THE DESIGN OF THE UNECE HGV DVS FOR TECH NEUTRAL CAB DESIGN

EQUIVALENCE BETWEEN THE EXISTING METHOD AND PROPOSED AMENDMENT

Original method in the standard - Front

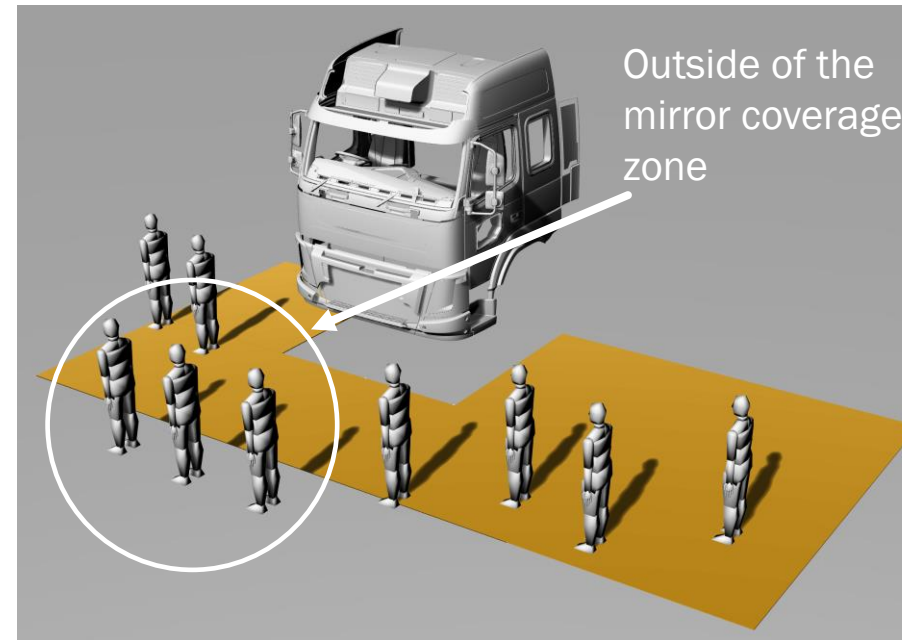
- The new version (option 3 or option 4) once again allows manufacturers to gain volume by making changes to the **side of the vehicle** and this means that the original method in the current standard and the amendment version **are not equivalent**
- This can be demonstrated in the example below, in both cases the 3 VRUs directly in front of the cab are in a blind spot between direct vision and indirect vision

The vehicle **fails** the minimum requirement to the front and must be improved – e.g. lowered overall – lower windscreen and dashboard

The vehicle fails the minimum requirement to the front and must be improved – however manufacturers can gain volume by improving performance to the sides and not the front in this version and can then pass **NO improvement to frontal direct vision blind spots**

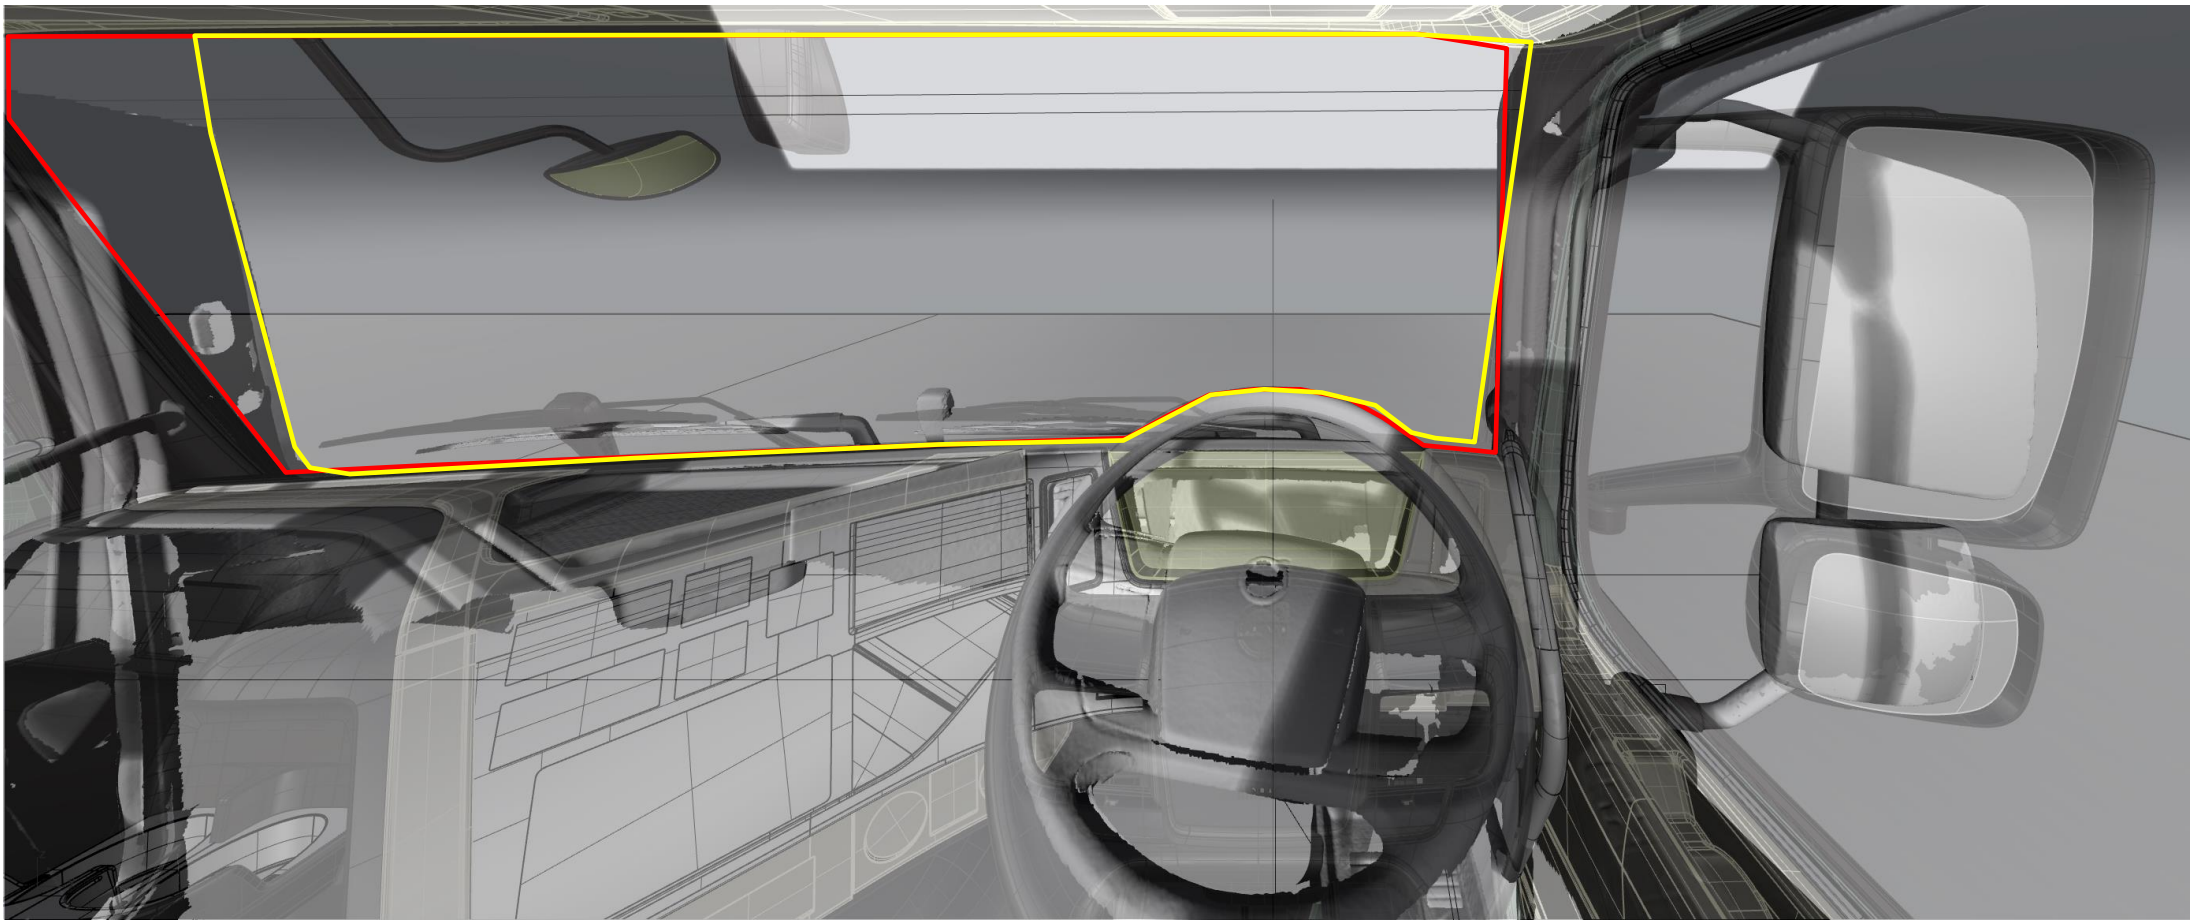
- The TfL DVS method produced a score for the Volvo FM which meant that it not could achieve a three star rating.
- In 2024 3 star becomes the minimum requirement
- The TfL DVS does not take the separated approach (this was developed for the UNECE version)
- Volvo therefore redesigned their truck to improve direct vision to the sides only to improve the design

- If we overlay the new and old designs we can see that the new design (yellow path) has a lower edge for the passenger window allowing more volume to be seen to the side
- The red path shows the old design

- If we overlay the new and old designs we can see that the new design (yellow path) has the same dashboard height. Therefore front VRU distance will be the same, no improvement to front direct vision.
- Other improvements were narrower A-Pillars, reduced obscuration by the mirror housings.
